RE: Hydrogen Energy California Project  
Application for Certification 08-AFC-8

# Responses to CEC Data Requests Set Two (Nos. 133 through 152)

## Revised Application for Certification (08-AFC-8) for HYDROGEN ENERGY CALIFORNIA Kern County, California

Figure 133-1 (4)

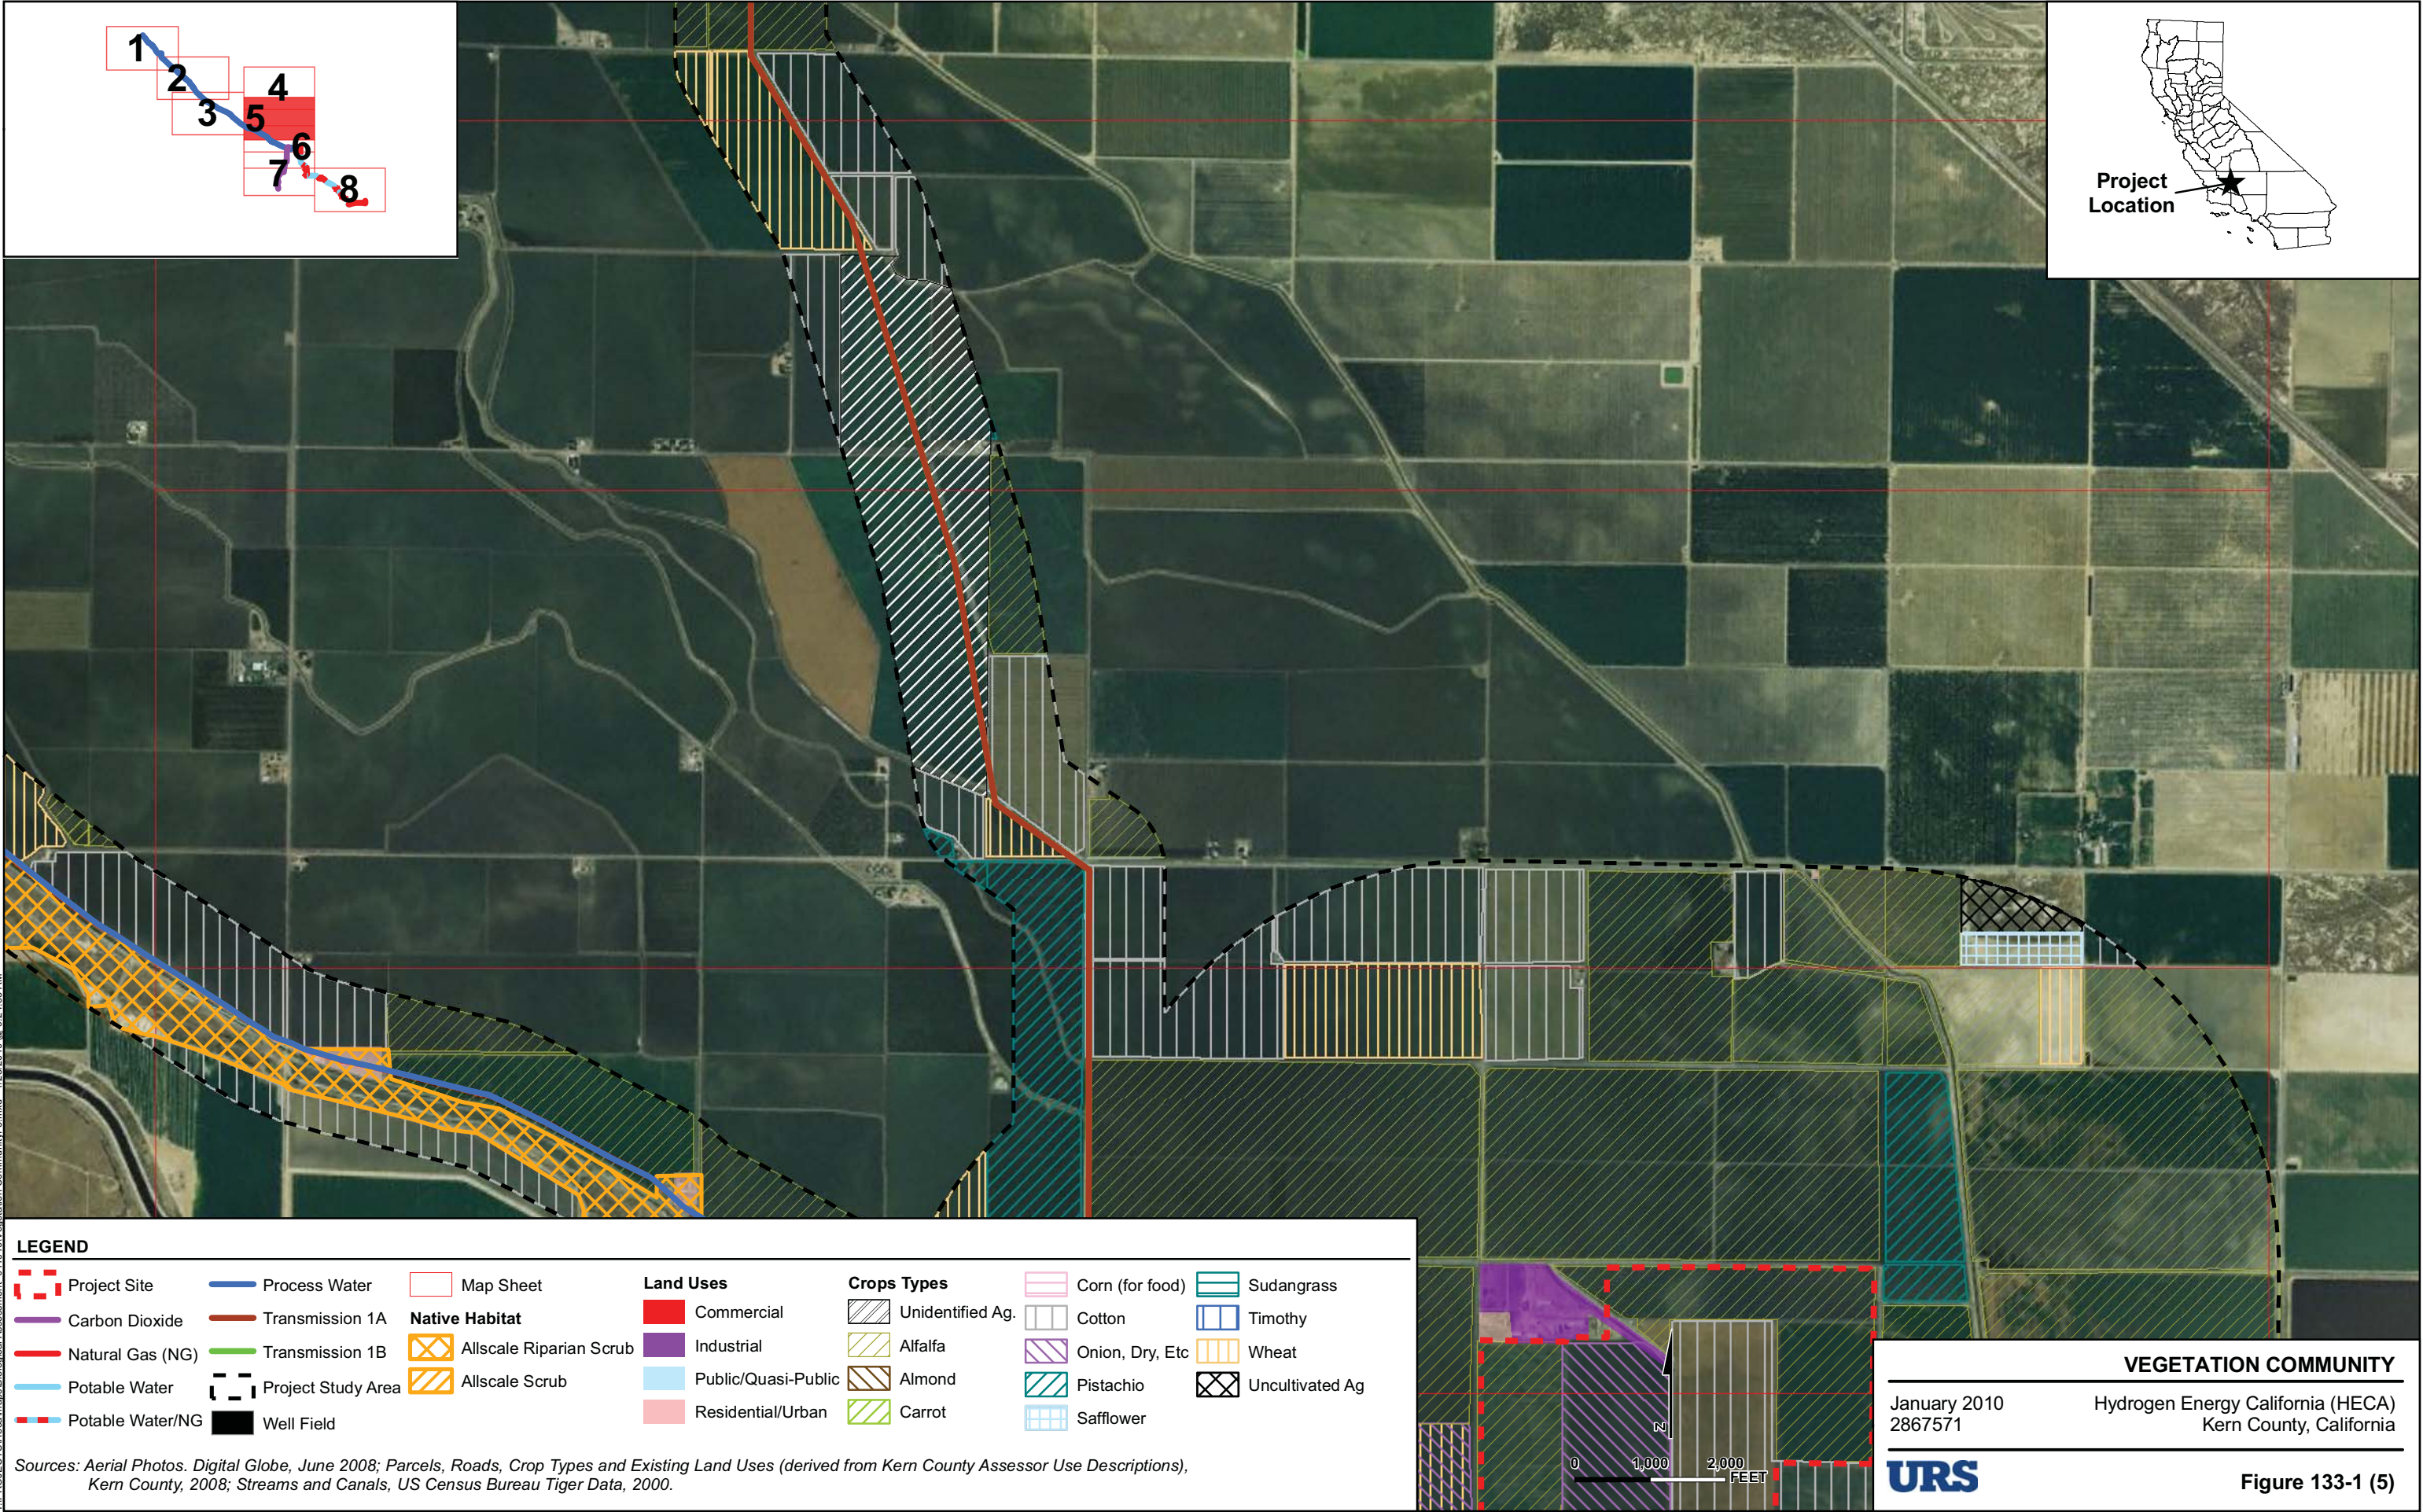
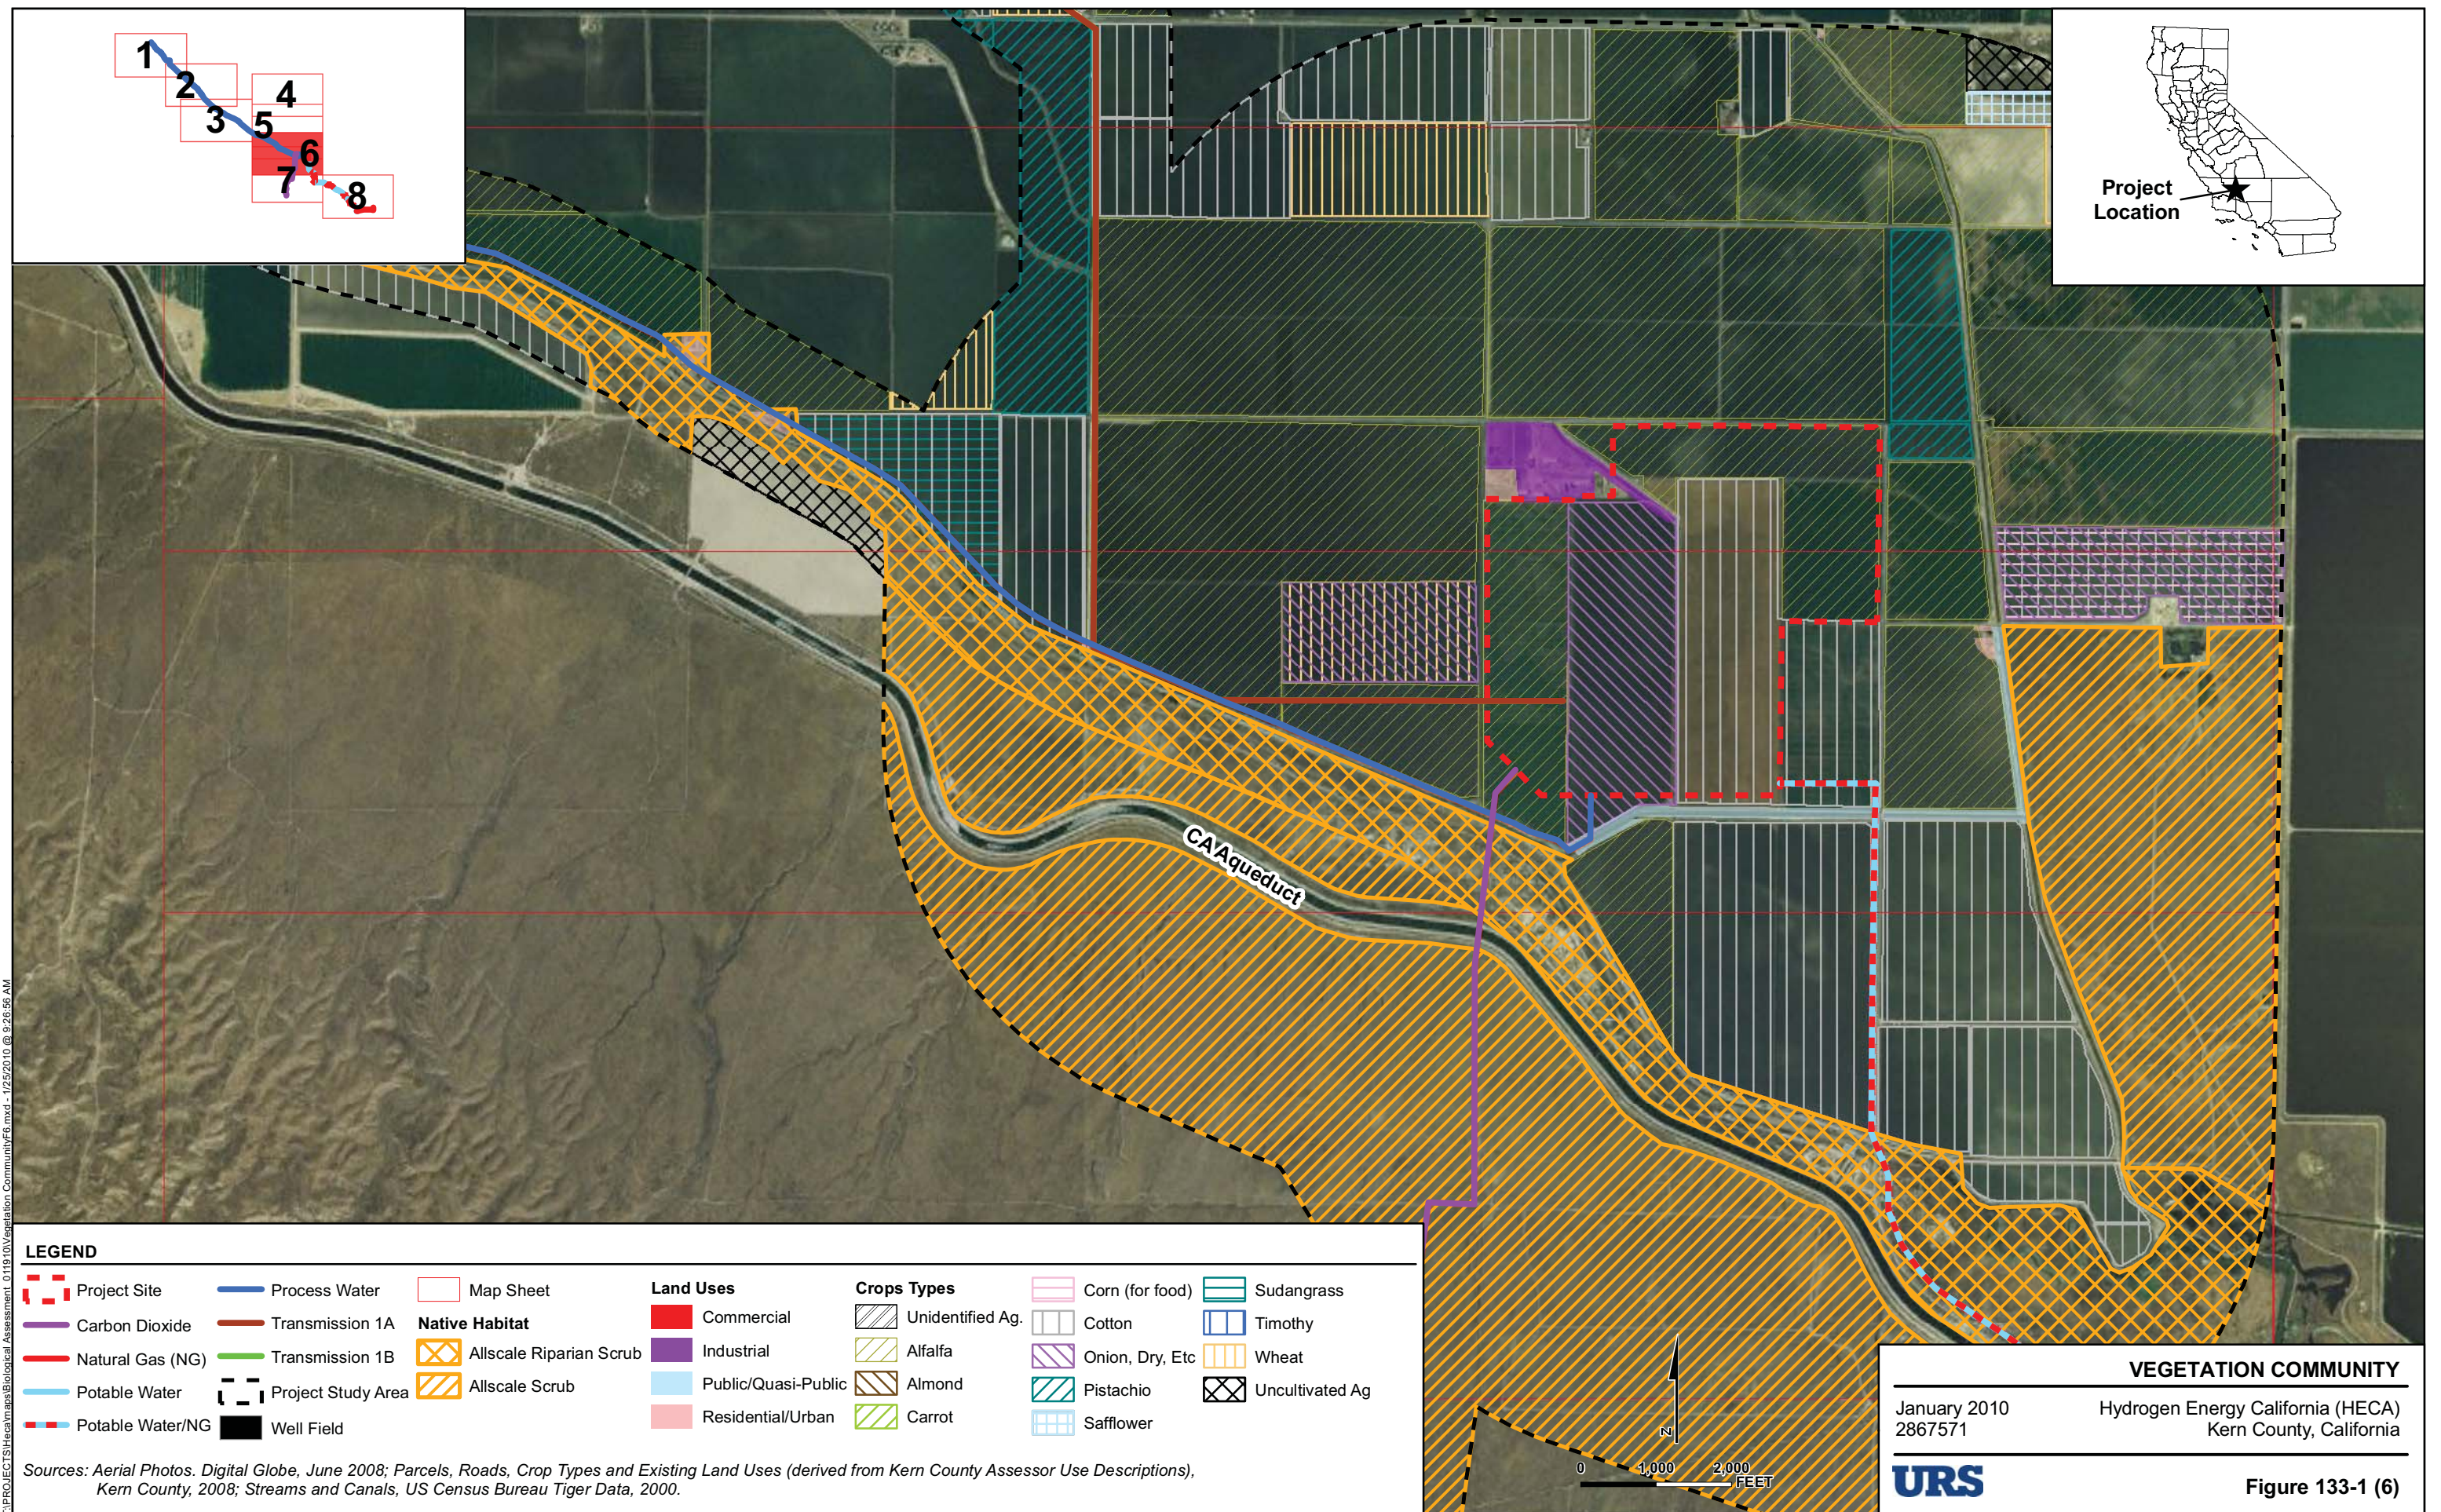
- 133. *Please provide a vegetation community map for the Biological Resources Study Area shown on Figure 5.2-1 in the Revised AFC. If possible, please prepare this figure at a scale of approximately 1:2,000 feet on a current aerial photograph. The vegetation community map must show the project site, all project linear facilities, and the broader study area that was surveyed as part of the Biological Resources Study Area of the Revised AFC.***

Figure 133-1 presents a vegetation community map for the Biological Resources Study Area that was referred to in the Revised Application for Certification (AFC). The figure has been prepared at the requested scale on an aerial base.
